IMPORTANT SAFETY RECALL

SUBJECT: SAFETY RECALL: RECARO ERGO M DRIVER SEAT

Service Bulletin No. 422

| <i>SUBJECT</i> | RECARO ERGO M DRIVER SEAT TETHER BAR | | | | | | |

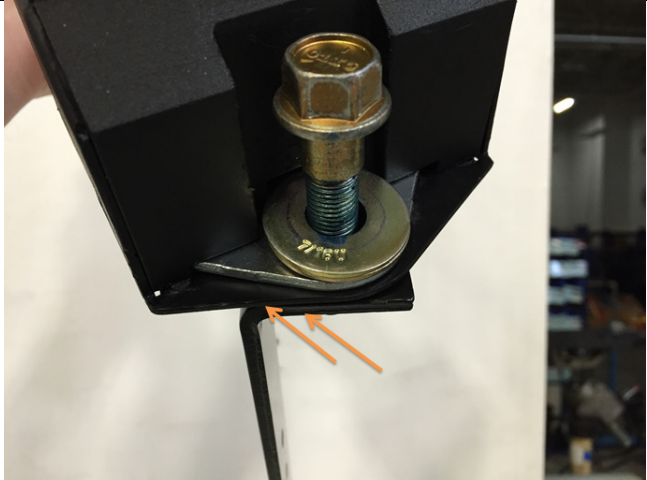
9. Place the tether bar in a vice or clamp to a tabletop within 2-3” of the modified end of the bar.
10. Place two 7/16” washer (30855207) under the head of 7/16-20 x 1-3/4” bolt (30817907). Insert the bolt/washer combo thru the retractor as shown.
11. Align the bottom edge of the retractor with the bottom edge of the tether bar.
Torque the bolt to 50 Nm

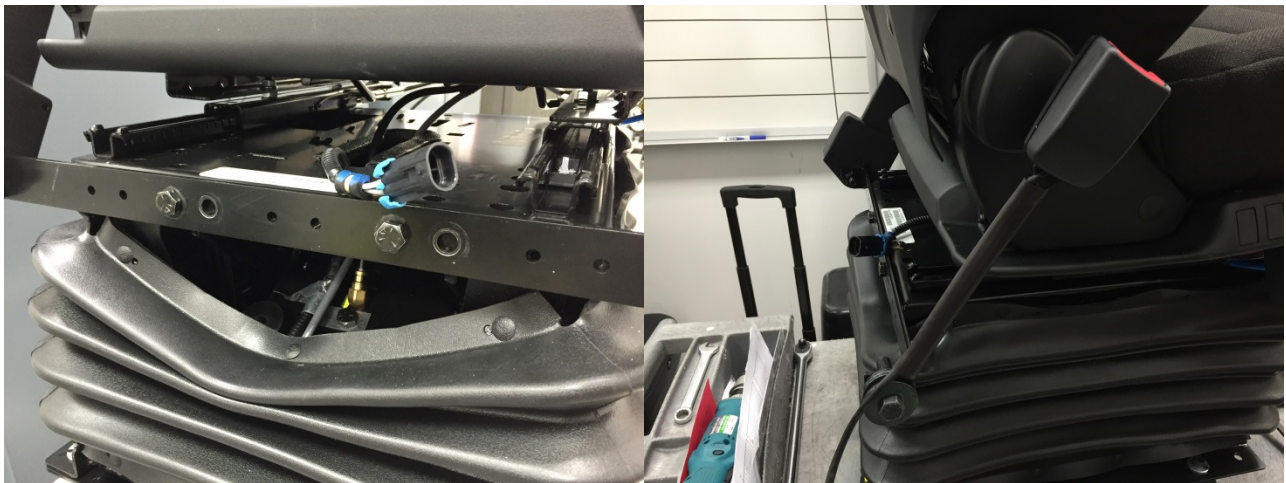
12. Install the tether bar back to the suspension using the alternate mounting holes that shift the assembly to the seat’s right.
Torque the tether bar bolts to 22 Nm

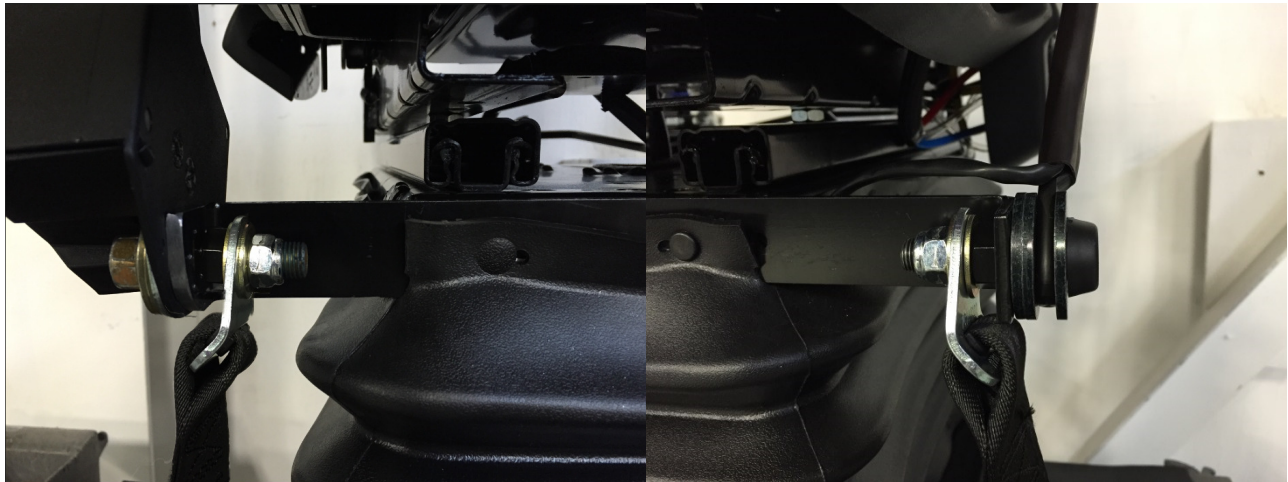
13. If the buckle does not need to be replaced, proceed to the next step.
 Install seatbelt buckle (N/O-30987307E) with bolt (30819307) and washer (30822707) to appropriate side of the tether bar.
NOTE: On N/O buckle, use 2 more washers (30822707) as spacers between the buckle and the tether.

14. Position the buckle to match the angle of the belt retractor.
 Torque to 50 Nm
